HARTING Product Change Notification

PCN/18/009/C+N

Product range: Han / Han C

Title: Han C female contacts new shape - External.docx

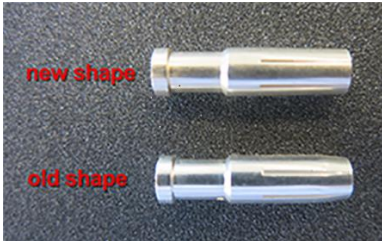
We are glad to inform you about a product modification on the Han[®] C female contacts. The shape of the Han[®] C female contacts in the mating area will change from “tulip”-design to a “cone”-design as showed in the picture below.

Main target of this modification is a significant reduction of the mating / unmating forces.

With the new shape these forces will be decreased by approximately 40 % compared to the current existing Han® C female contact.

The modification will be done for all Han® C female contacts independently from the performance level / surface plating and will be implemented by April 2019.
